## Summary of Comments on 121328205\_PAA review 01-26-17.pdf

Page: 48

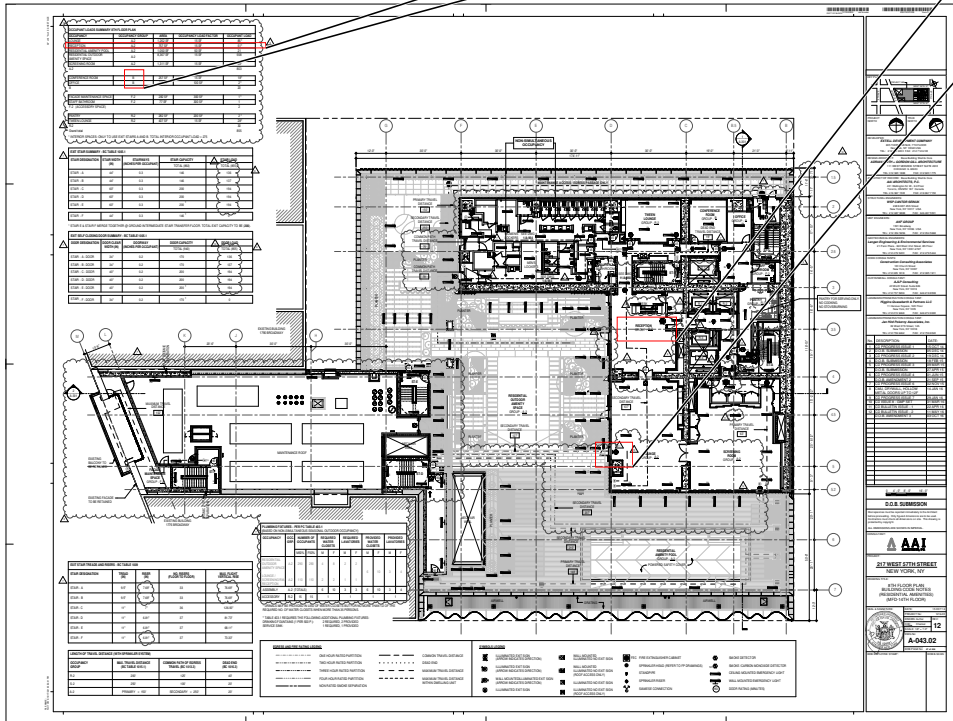
Author: dtitus Subject: Rectangle Date: 1/26/2017 12:41:00 PM  
remove occupant load for reception area.

Author: dtitus Subject: Rectangle Date: 1/26/2017 12:26:11 PM  
Accessory to residential use. Please indicate as R-2

Author: dtitus Subject: Rectangle Date: 1/26/2017 12:33:29 PM  
Indicate as non-simultaneous occupancy.

Provide note: non-simultaneous to lounge and screening room.

Author: dtitus Subject: Rectangle Date: 1/26/2017 12:37:07 PM  
Exit not permitted unless non-simultaneous reception, lounge and screening room becomes one PA with the outdoor area.

Author: dtitus Subject: Rectangle Date: 1/26/2017 12:50:11 PM  
cigar room: Provide net area of space and number of persons to be accommodated based on (15) sq. ft./person as per table BC 1004.1.1.

Author: dtitus Subject: Rectangle Date: 1/26/2017 12:52:09 PM  
Commercial kitchens need not be separated from the restaurant seating areas that they serve as per Table 508.4.4, provided:  
1. The cooking equipment is vented directly to the outdoors; and  
3. Fire protection systems in accordance with the provisions of Section 903 and 904 are provided on the cooking facilities side of the curtain, or any opening between the kitchen and dining space, located within 24 inches (609 mm) of the curtain or opening, and spaced not more than 48 inches (1219 mm) on center if the opening is more than 60 inches (1524 mm) wide.

BC 903.2.11.9 Commercial cooking operations. An automatic sprinkler system shall not be installed in a commercial kitchen exhaust hood and duct system. Fire extinguishing systems shall be installed in commercial cooking systems in accordance with Section 904.11.

BC 904.2.1 Hood system suppression. Each required commercial kitchen exhaust hood and duct system required by the New York City Fire Code or the New York City Mechanical Code to have a Type I hood shall be protected with an approved automatic fire-extinguishing system installed in accordance with this code.

Kitchen shall also comply with MC 506, 507, and 508; PC 802.1.7 and 1003.3.1. Please verify on MH/PL plans.

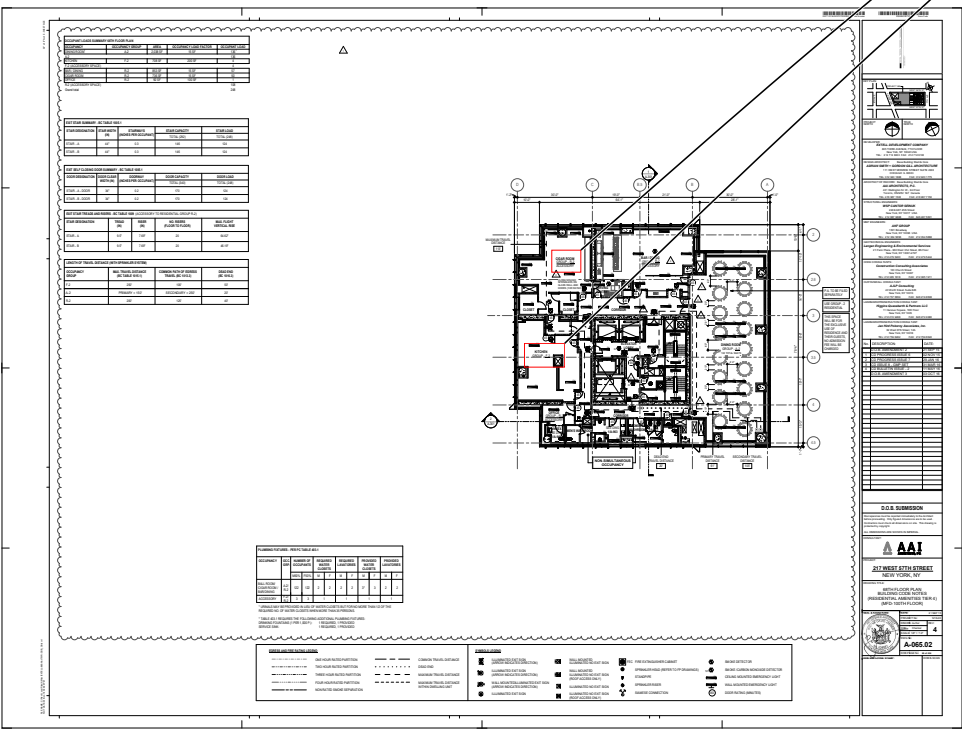
Provide net area of space and number of persons to be accommodated based on (15) sq. ft./person as per table BC 1004.1.1. (roof acc. to all tenants ) or provide note: private roof terrace acc. to penthouse unit.

2nd kitchen not permitted if proposed for penthouse.

Commercial kitchens need not be separated from the restaurant seating areas that they serve as per Table 508.4.4, provided:

1. The cooking equipment is vented directly to the outdoors; and
3. Fire protection systems in accordance with the provisions of Section 903 and 904 are provided on the cooking facilities side of the curtain, or any opening between the kitchen and dining space, located within 24 inches (609 mm) of the curtain or opening, and spaced not more than 48 inches (1219 mm) on center if the opening is more than 60 inches (1524 mm) wide.

BC 903.2.11.9 Commercial cooking operations. An automatic sprinkler system shall not be installed in a commercial kitchen exhaust hood and duct system. Fire extinguishing systems shall be installed in commercial cooking systems in accordance with Section 904.11.

BC 904.2.1 Hood system suppression. Each required commercial kitchen exhaust hood and duct system required by the New York City Fire Code or the New York City Mechanical Code to have a Type I hood shall be protected with an approved automatic fire-extinguishing system installed in accordance with this code.

Kitchen shall also comply with MC 506, 507, and 508; PC 802.1.7 and 1003.3.1. Please verify on MH/PL plans.
